Tom Myers, Ph.D.
Hydrologic Consultant

Technical Memorandum
Review of Underground Injection Control Permit and Application
Gunnison Copper Project

January 6, 2017

Dragoon, Arizona

Figure 17: Figure 36 from Attachment A-2 showing the drawdown from the pump test at well NSH-015.

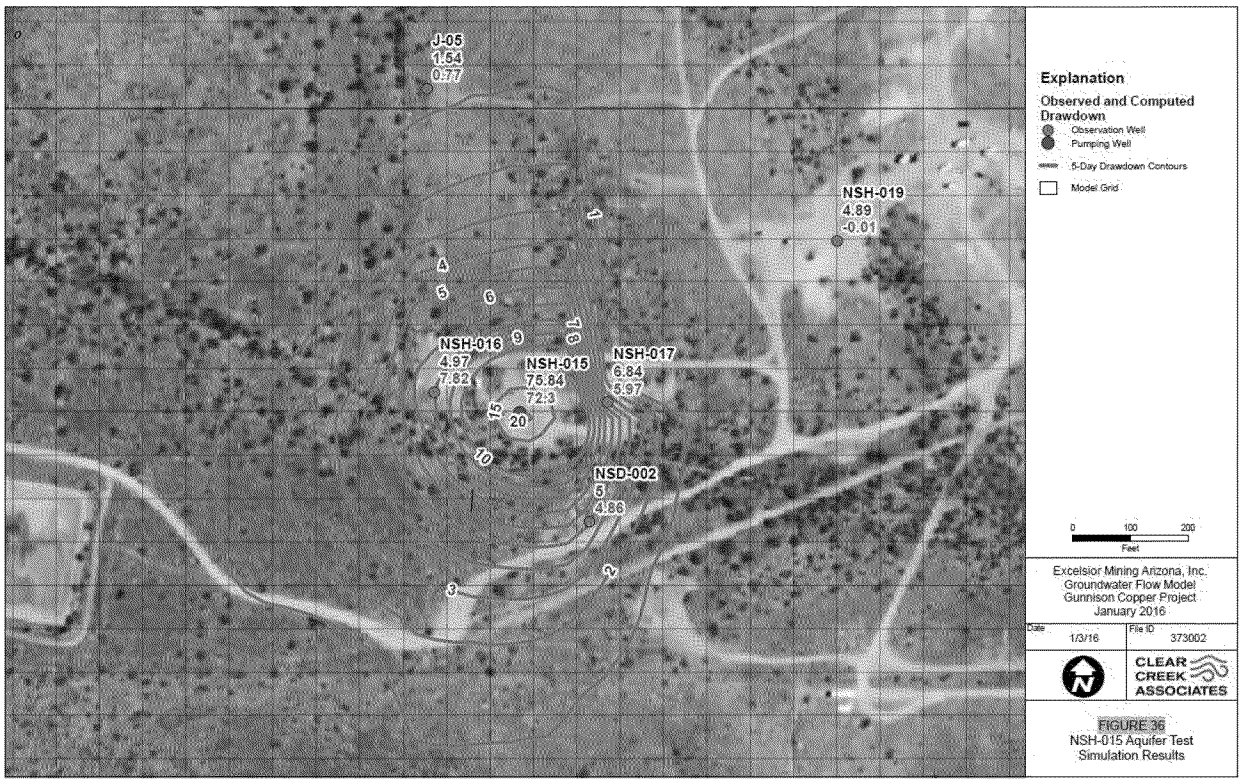
There is little data for transient calibration, which would attempt to match observed water level changes due to a stress applied to the aquifer by changing storage coefficients. The modelers calibrated to data for a pump test at NSH-015, which included a series of four short-term pumping rates followed by a several-day period of constant pumping at 85 gpm. Drawdown at NSH-019 had been predicted to be 4.89 feet but the model simulated just 0.01 feet (Figure 17). This is due to the fracture-dominated flow system and that drawdown depends on the observation well being developed in the same fracture system as the pumping well.

These results demonstrate future problems that will occur with the system. Injection of leachate into a fracture zone that does not have a collection well or a control well will allow flow to exit the system. Figure 17 shows however that there is likely an inappropriate model flow barrier between NSH-015 and NSH-019 since the observed drawdown, as noted 4.89 feet, occurs about 500 feet east of the simulated 1-ft drawdown contour. The simulated material

properties may not connect high K values to create an actual zone. The model cells are much larger than any fracture zone and the fracture intensity would depend on the observed fractures within the cell.
